From: [Troy Monroe](#)
To: [Nathan McLeod](#); [Aaron Wilson](#); [Ryan Sudbury](#); [Dave DeGrandpre](#); [Ellen Buchanan](#)
Cc: [Traci Freshour](#)
Subject: RE: Roseburg Forest Products annexation
Date: Wednesday, November 20, 2024 3:52:10 PM
Attachments: [image001.png](#)
[image002.png](#)
[image003.png](#)

Here are comments from Engineering. Below is a map of proposed street and utility easements (Ellen may have a more detailed street location – we aren't concerned with what's in the middle, but need to make sure the utility and streets meet existing infrastructure locations). We need to be able to "loop" utilities, and streets, and there are two southern connecting points (Coal Mine Rd and Bulwer St). An east/west street and utility connection along the southern properties' boundary is also required.

Water Condition

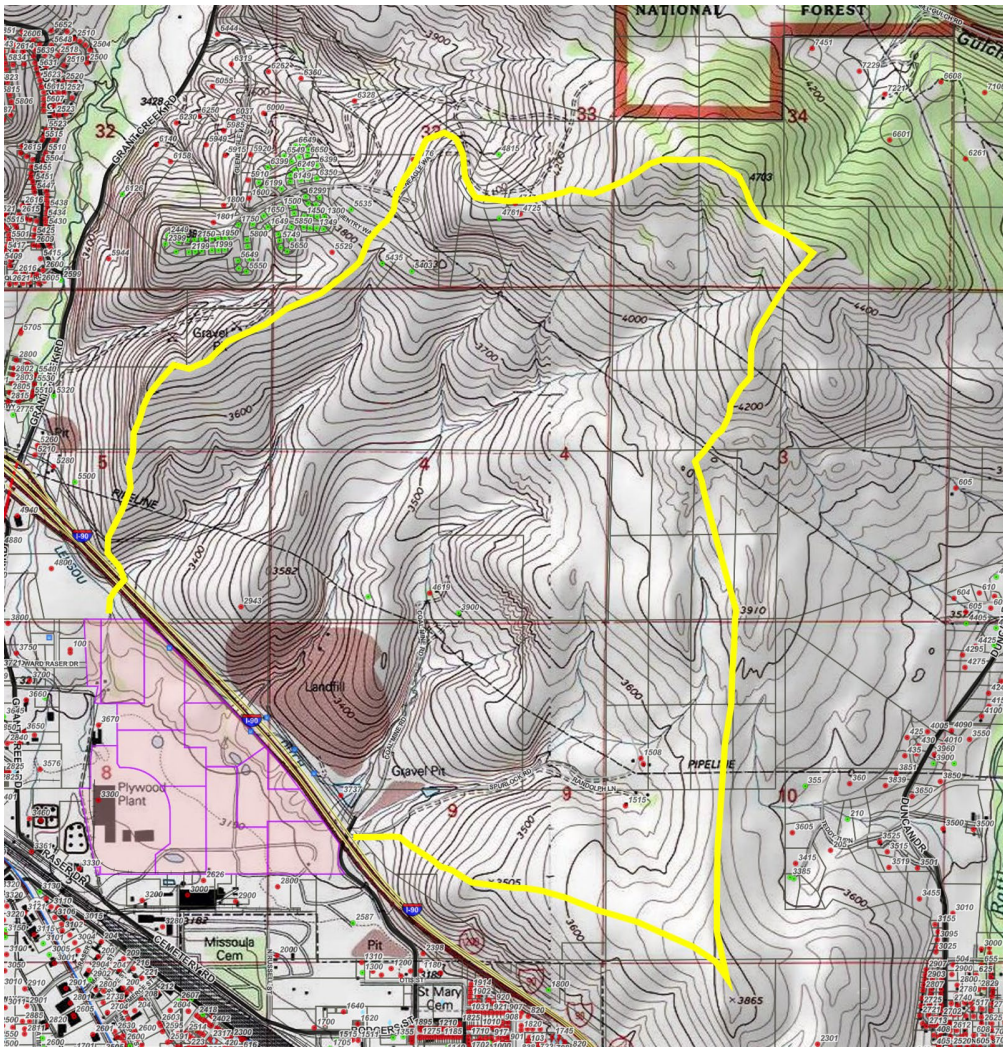
Water infrastructure is present near the property boundary, but no City water infrastructure exists within the site boundaries. Water system improvements are required before any connection is authorized. Improvements will at a minimum include looped watermain connection from Howard Raser Ave to Burns Street to Raser Drive, along with utility easement and/or right of way. Additional water main extensions, tanks, wells, other water infrastructure, and easements may be required by Public Works and Mobility based on proposed development. The size, capacity, alignment, and location of necessary improvements and easements will be determined based on specific development proposals through the City of Missoula Public Infrastructure Review Process. Public Works and Mobility may allow phased construction of improvements. No water system capacity shall be certified until a specific development proposal reaches Stage 3 of the City of Missoula Public infrastructure review process.

Sanitary Sewer Condition

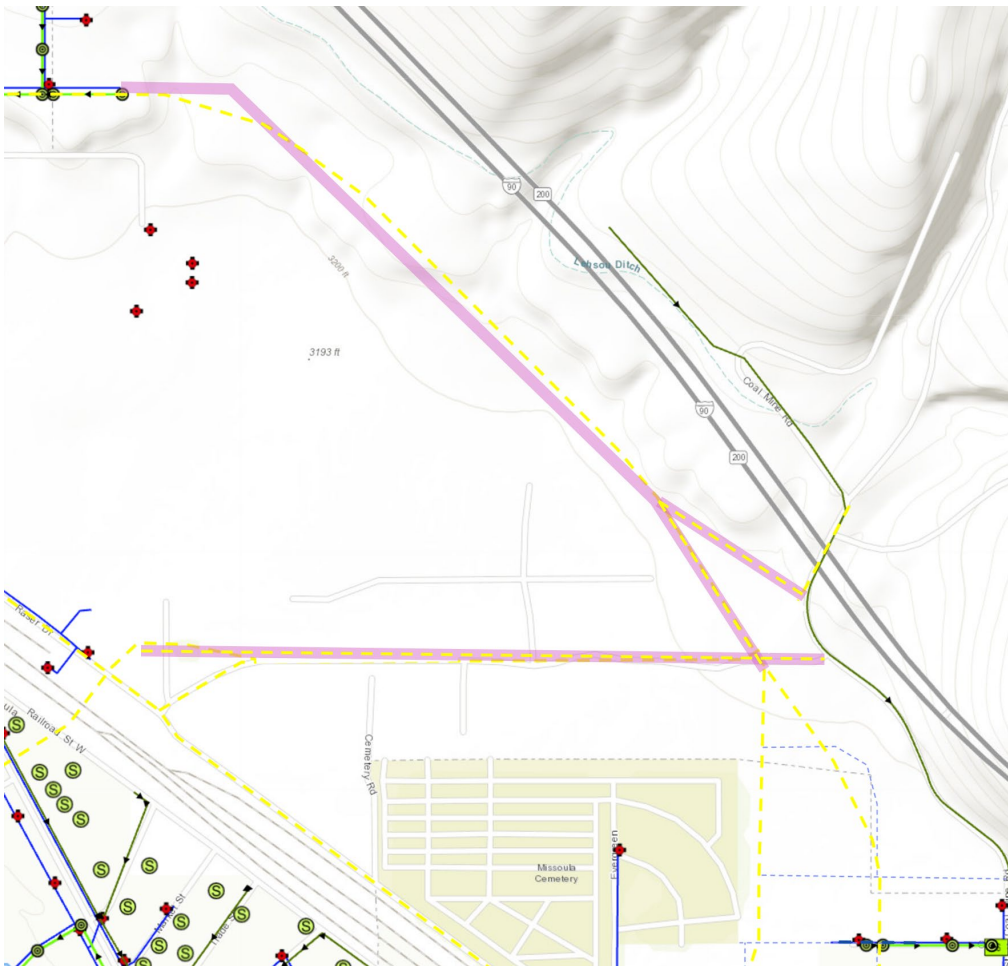
Sanitary sewer collection infrastructure is present near the property boundary, but no City sanitary sewer collection infrastructure exists within the site boundaries. Sanitary sewer collection system improvements are required before any connection is authorized. Improvements will at a minimum include construction of a new lift station (including wet well, pumps, control system back-up power, & appurtenances), force main, and gravity sanitary sewer mains, along with utility easement and/or right of way. Additional necessary improvements will be determined by Public Works and Mobility based on proposed development. The size, capacity, alignment, and location of necessary improvements and easements will be determined based on specific development proposals through the City of Missoula Public Infrastructure Review Process. Public Works and Mobility may allow phased construction of improvements. Downstream sanitary sewer collection system improvements may be required, as determined by Public Works and Mobility based on specific development proposals. No sanitary sewer system capacity shall be certified until a specific development proposal reaches Stage 3 of the City of Missoula Public infrastructure review process.
